## **GALTS GULCH SUBDIVISION**

APPLICATION NUMBER 6 DATE December 3, 2015

REQUEST Subdivision

## DETAIL SITE PLAN

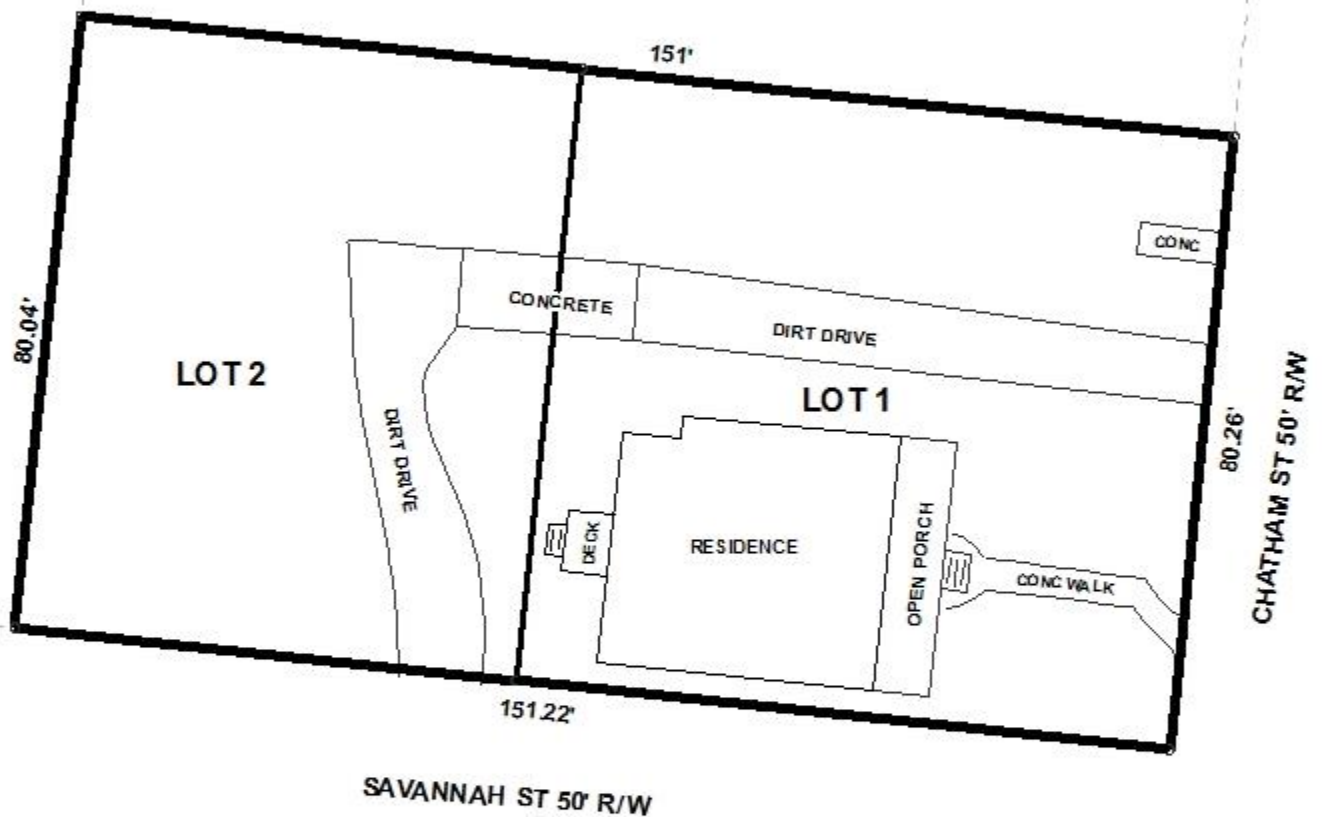
- D. Dedicate the corner radius (25' minimum or as approved by the City Engineer and Traffic Engineer) at the Southeast corner of LOT 1.
- E. Provide the Surveyor's, Owner's (notarized), Planning Commission, and Traffic Engineering signatures.

The site fronts Chatham Street and Savannah Street, both minor streets with curb and gutter. Both roads are illustrated as having existing compliant 50' rights-of-way, making no dedications necessary. However, dedication of the corner radii at Chatham and Savannah Street per Section V.D.6. of the Subdivision Regulations should be required if determined necessary by the City Engineer.

The proposed lots appear to meet the maximum width to depth ratio as regulated by Section V.D.3. of the Subdivision Regulations. The lot sizes in square feet and acres are depicted on the plat; however, neither of the proposed lots meet the required 7,200 square foot minimum lot size as required by Section V.D.2. of the Subdivision Regulations. Small property sizes are not uncommon within the Oakleigh Garden Historic District and, as proposed, the smallest lot will be 5,255 ± square feet. If approved, a waiver of section V.D.2 of the Subdivision Regulations will be required.

Lot 1 is developed with a residence and with one existing curb-cut to Chatham Street and Savannah Street. If approved, a note should be placed on the Final Plat stating each lot is limited to 1 curb-cut with the size, design, and exact location to be approved by Traffic Engineering, and conform to AASHTO standards. Lot 1 should be denied access to Savannah Street.

The 25-foot minimum building setback line, required in Section V.D.9., is not shown on the preliminary plat. However the proposed site is located in a Historic District, and as such, the minimum building setback lines can be determined by the application of the Historic Overlay District regulations contained within the Zoning Ordinance. Therefore a waiver of Section V.D.9 of the Subdivision Regulations is recommended, to allow for the application of the Historic District Overlay. Setbacks should comply with the Zoning Ordinance (Historic District Overlay).

- 1) revision of the plat to provide dedication of the corner radii at Chatham and Savannah Street per Section V.D.6. of the Subdivision Regulations, if determined necessary by the City Engineer;
- 2) retention of the lot sizes in square feet and acres;
- 3) placement of a note on the Final Plat stating that each lot is limited to 1 curb-cut with the size, design, and exact location to be approved by Traffic Engineering, and conform to AASHTO standards;
- 4) placement of a note on the Final Plat stating Lot 1 is denied access to Savannah Street;

- 5) placement of a note on the Final Plat stating setbacks will comply with the Zoning Ordinance (Historic District Overlay);
- 6) compliance with Engineering comments: *“The following comments should be addressed prior to submitting the FINAL PLAT for acceptance and signature by the City Engineer: A. Provide all of the required information on the SUBDIVISION PLAT (i.e. signature blocks, signatures, certification statements, written legal description, required notes, legend, scale, bearings and distances) that is required by the current Alabama State Board of Licensure for Professional Engineers and Land Surveyors. B. Provide the site location in the vicinity map. C. Review and revise the written legal description or provide a copy of the latest recorded deed as it does not seem to match the Probate records. D. Dedicate the corner radius (25’ minimum or as approved by the City Engineer and Traffic Engineer) at the Southeast corner of LOT 1. E. Provide the Surveyor’s, Owner’s (notarized), Planning Commission, and Traffic Engineering signatures. F. Add a note to the SUBDIVISION PLAT stating that a Land Disturbance permit will be required for any land disturbing activity in accordance with Mobile City Code, Chapter 17, Storm Water Management and Flood Control); the City of Mobile, Alabama Flood Plain Management Plan (1984); and, the Rules For Erosion and Sedimentation Control and Storm Water Runoff Control. G. Add a note to the Plat stating that the approval of all applicable federal, state, and local agencies (including all storm water runoff, wetland and floodplain requirements) will be required prior to the issuance of a Land Disturbance permit. H. Add a note that sidewalk is required to be constructed, and/or repaired, along the frontage of each lot, or parcel, at time of development, unless a sidewalk waiver is approved. I. Provide a copy of the FINAL PLAT to the Engineering Dept. for review prior to obtaining any signatures. J. Provide a copy of the Final Plat along with the original when submitting for City Engineer signature.”*;
